ENQUIRIES: IAN HARRIS  
PROJECT NO: 38509-SYD-C

### **181 ALLAMBIE ROAD, ALLAMBIE HEIGHTS – OVERLAND FLOW FLOODING & STORMWATER**

This letter has been prepared in response to council's Engineering Referral Response memo dated 25<sup>th</sup> February 2019 regarding a request for additional information on the upstream catchment overland flow conveyance across the site post development.

Upstream Catchment

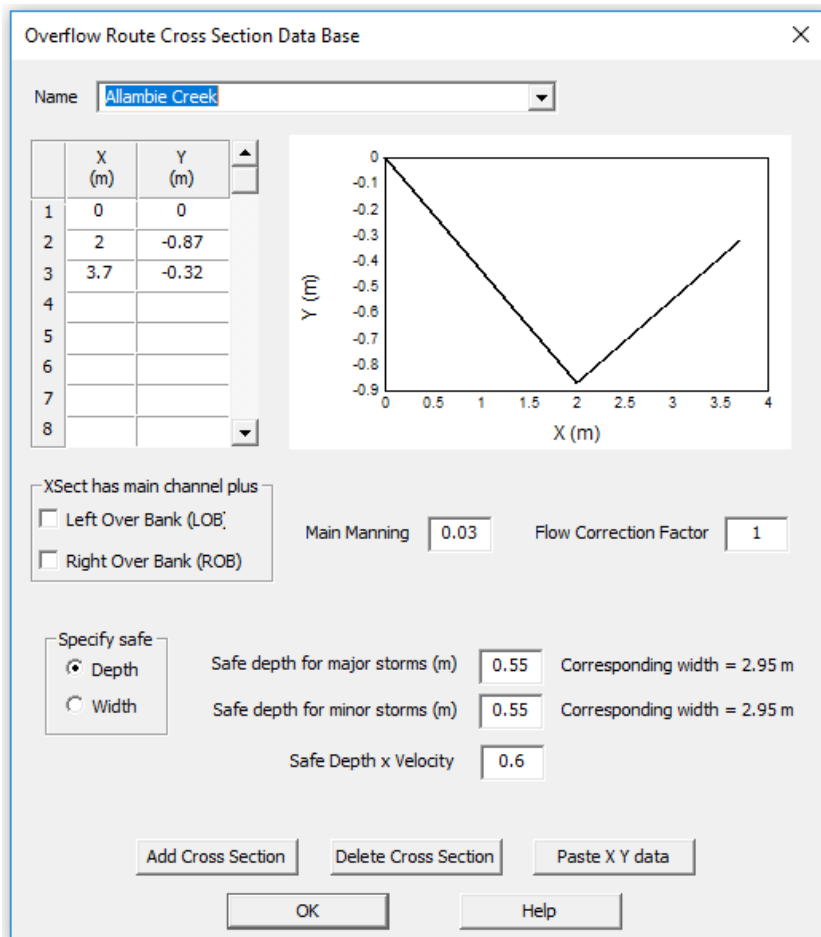
- Catchment plan highlighting the full upstream catchment(s). – **Upstream catchment plan included in design calculation sheet.**
- A detailed analysis for any overland flow paths in both pre-development and post-development

## 100 Year Rainfall Event - DRAINS Results

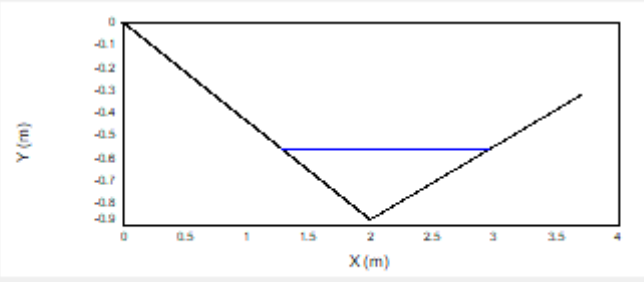
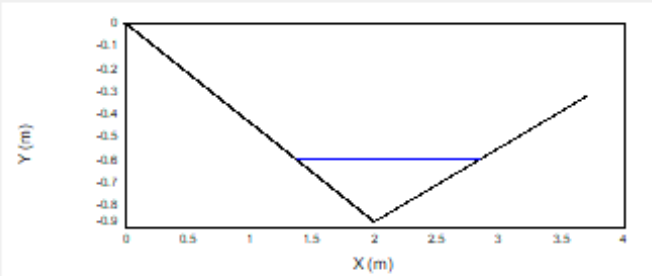
- Consideration is to be given to the capacity of the existing Council drainage infrastructure. – **Swale and culvert capacities have been assessment in the DRAINS model. The culvert can convey the 100 year flows but during a PMF event the water will overtop the culvert and discharge over the road.**

From the above 100yr rainfall event DRAINS results, the creek does not overtop in the 100yr event, with a maximum depth of flow of 0.311m.

## PMF Event – DRAINS Results

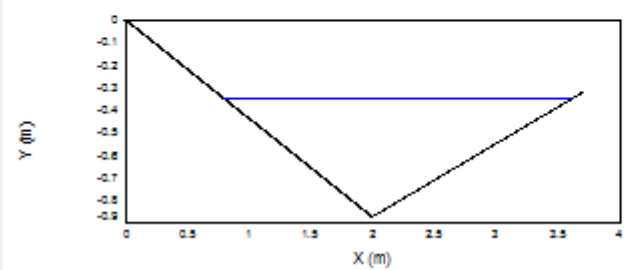
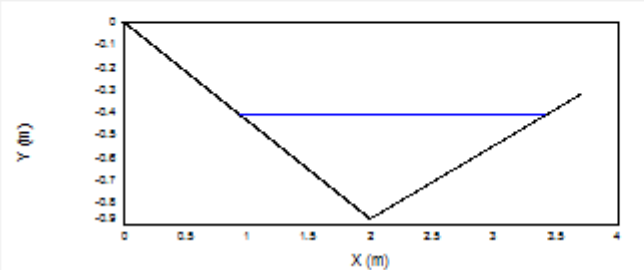
- Demonstration of compliance with flood related development controls, in particular Warringah LEP 2011 Section 6.3 and DCP 2011 Section E11. – **As noted below the development should be classed as “Residential” and as such is not subject to flood planning restrictions given that assessment of the upstream overland flow suggest that the site should be classed as low flood risk.**

From the above PMF rainfall event DRAINS results, the creek does not overtop in the PMF event, with a maximum depth of flow of 0.521m.

It is noted that the existing creek is quite steep which generates a high velocity of flow however, the proposed development does not contribute additional flow to the creek.
